Seabrook Station
Reply to Inspection Report 2000-11

REPLY TO INSPECTION REPORT 2000-11

NORTH ATLANTIC'S ALTERNATIVE PERSPECTIVES
TO ISSUES DESCRIBED
IN NRC INSPECTION REPORT 2000-11

EMERGENCY DIESEL GENERATOR B OPERABILITY DURING CYCLE 7

FIGURE 1
EDG-B Cycle 7 Lubricating Oil Strainer Delta-P

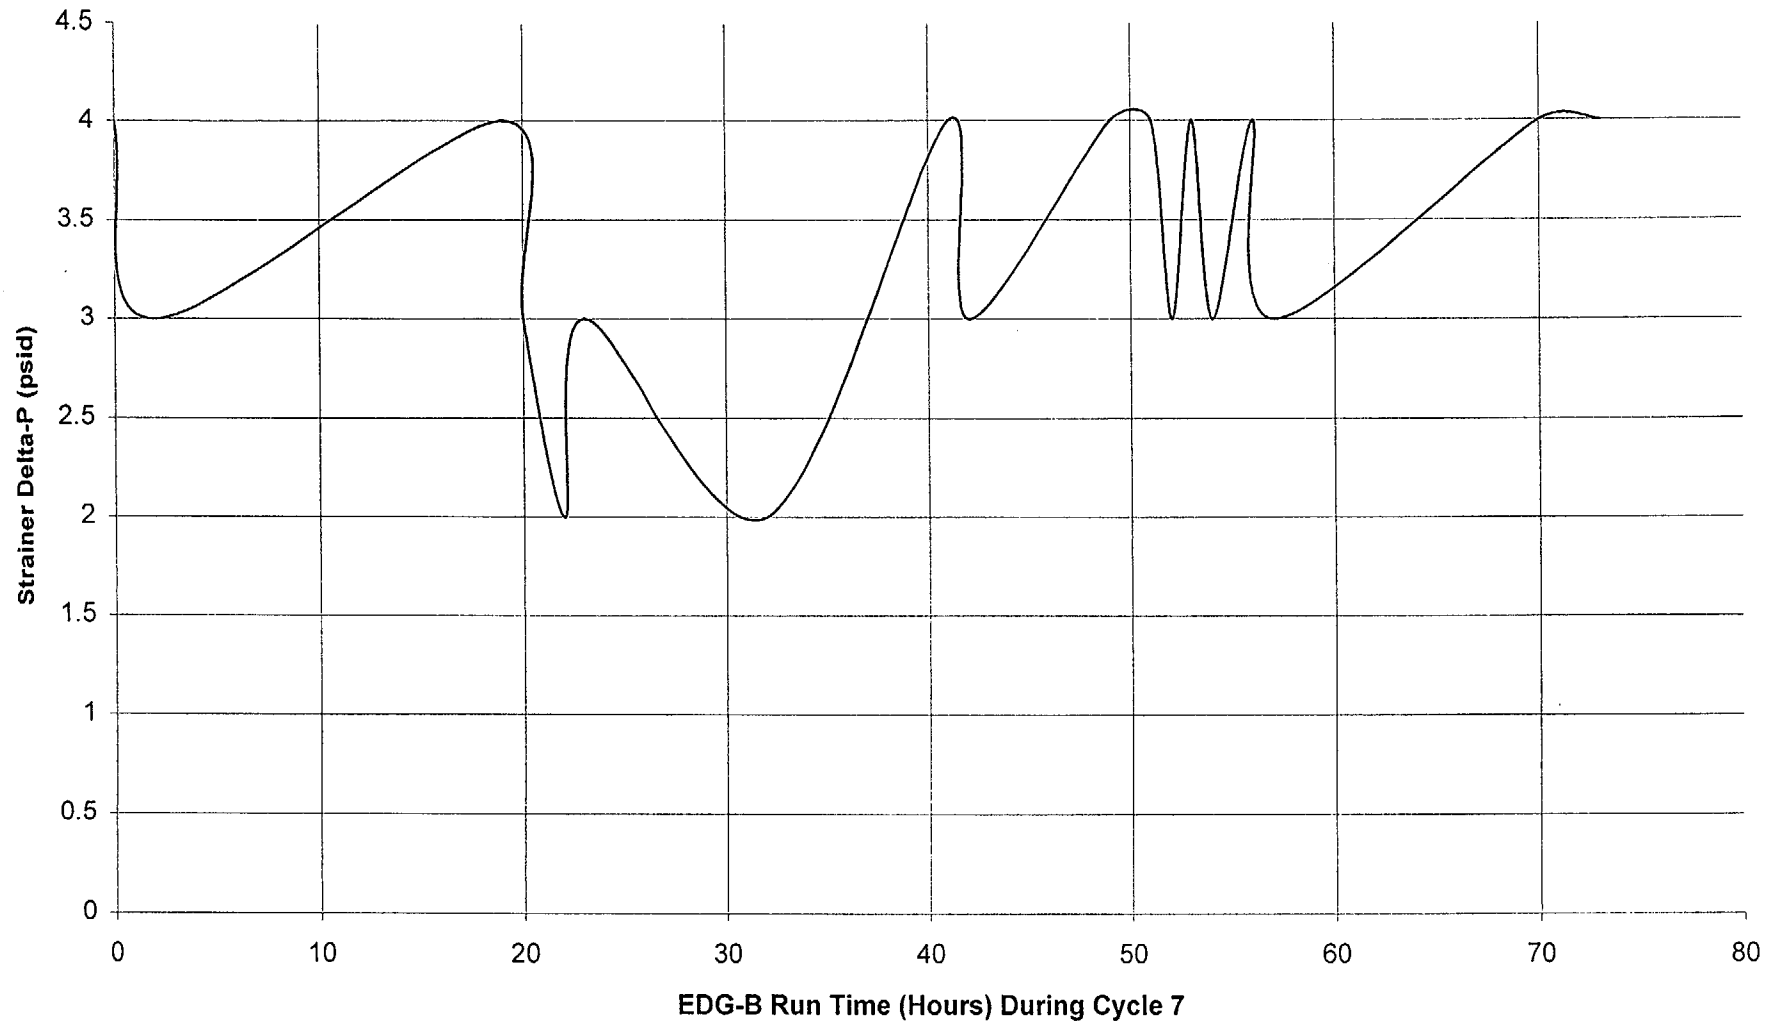
EDG-B lubricating oil strainer differential pressure remained within a normal range of approximately 2 to 4 psid throughout cycle 7. This is depicted on Figure 1. No lubricating oil strainer replacements or cleanings were required during the cycle. Prior to OR-07, the last time the strainers were replaced was in March 1997.

FIGURE 3
10/29/00 EDG-B 24-Hour Run Attempt
Lubricating Oil Strainer Delta-P Extrapolated Exponentially

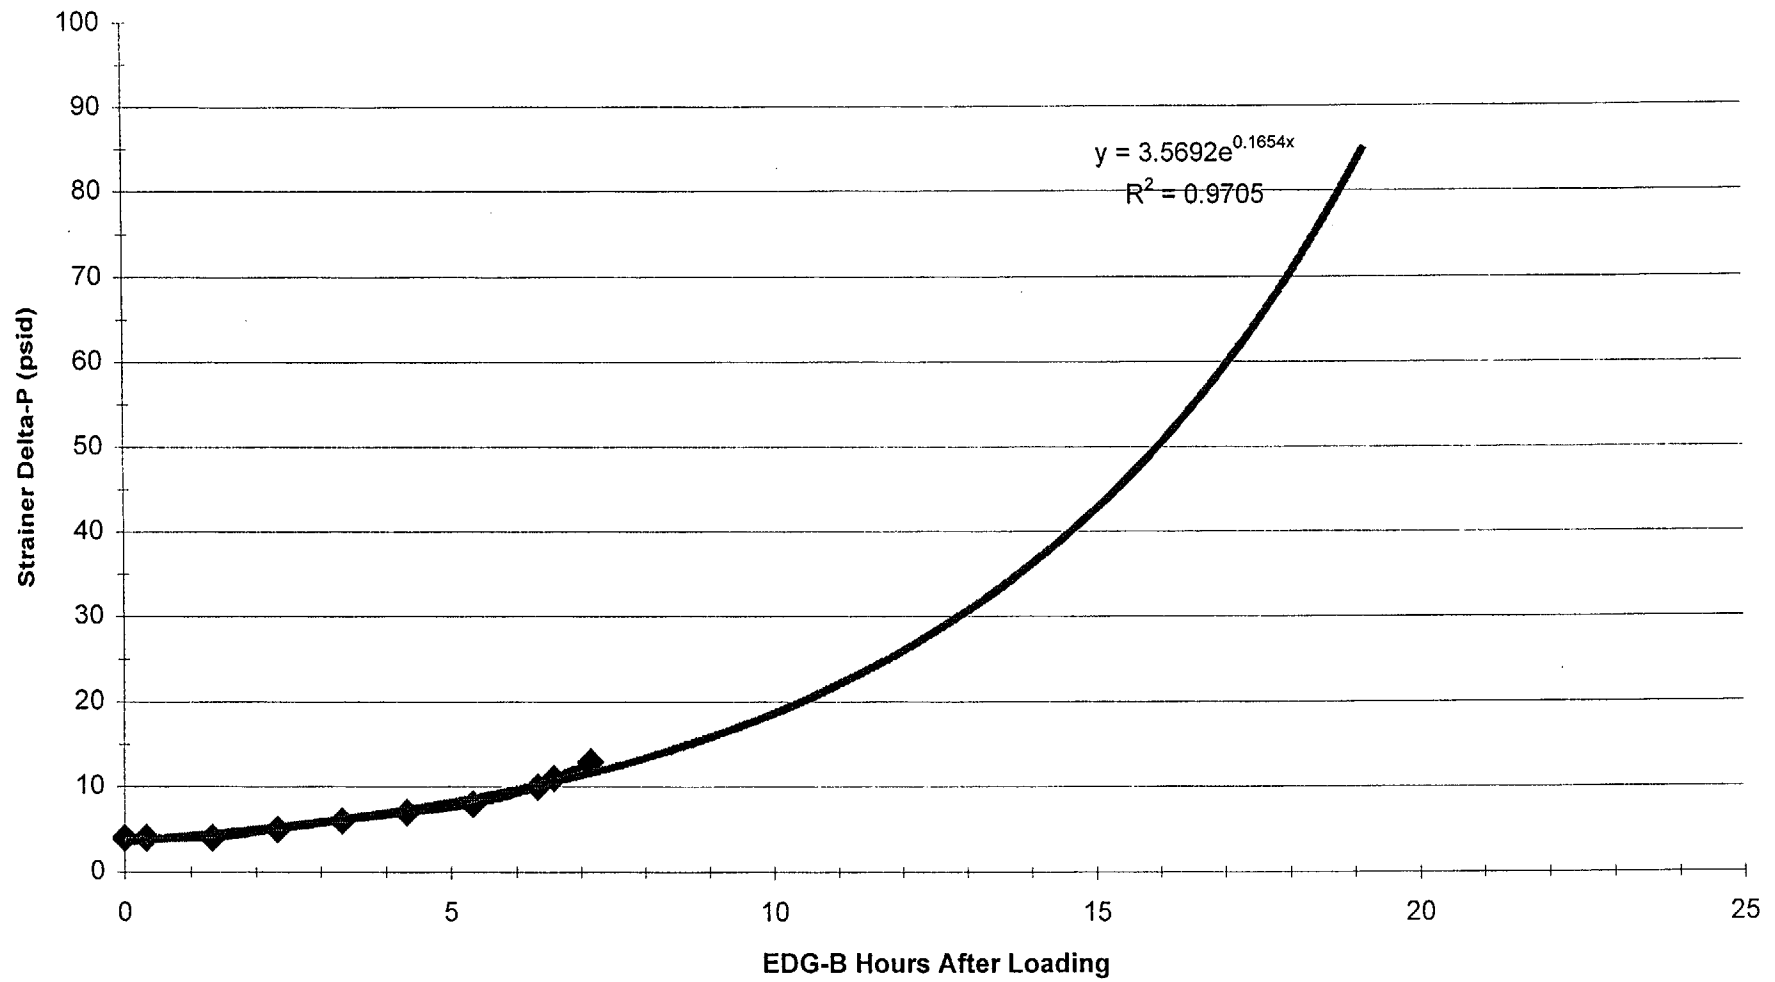
The first model determines the cumulative amount of time that EDG-B ran at load during the refueling outage up to the point that the engine would have tripped on low lubricating oil pressure as a result of strainer clogging due to accumulation of wear products. This is a very simplistic model that is overly conservative, and therefore potentially misleading in that it ignores the influence of the multiple engine starts and thereby the failure mechanism. However, it does provide the minimum bounding estimate. From October 24, 2000 through the first attempted 24-hour run on October 29, 2000, EDG-B was started a total of nine times with a total run time of 19.9 hours. Approximately 15.8 hours of this run time was with the engine loaded (some maintenance runs were conducted with the engine unloaded). During the first attempted 24-hour run on October 29, 2000, EDG-B ran for approximately 7 hours, 27 minutes (7.45 hours), at load before operators shut the engine down due to lubricating oil strainer differential pressure (during the course of the run the differential pressure increased from 4 psid to approximately 13 psid). However, had operators not taken action to shut the engine down, it is estimated based on the rate of strainer loading and the relationship between strainer differential pressure and engine oil pressure, that the engine would have been capable for running at load for another 8.5 hours. This would provide for a total loaded run time during the first 24-hour run October 29, 2000 of 15.966 hours.

The above estimate utilized an Excel program to extrapolate the strainer data collected during that run to roughly estimate when the engine would have tripped on low lubricating oil pressure. To more accurately model the entire run on October 29, 2000, the extrapolation included an estimate of the initial strainer differential pressure from the start of the run along with actual strainer readings taken during the run. This analysis also accounted for the auxiliary lubricating oil positive displacement pump, which starts prior to an engine trip on low lubricating oil pressure, such that the strainer differential pressure can reach 50 psid before the engine trips. Refer to Figure 3 for a depiction of the strainer differential pressure associated with the first 24-hour run on October 29, 2000. While there are some uncertainties associated with the extrapolation, such as accuracy of gauges, lubricating oil pressure trip setpoints, auxiliary oil pump start and relief pressure, etc., it provides a rough estimate of how long the engine would have operated for successfully during that run.
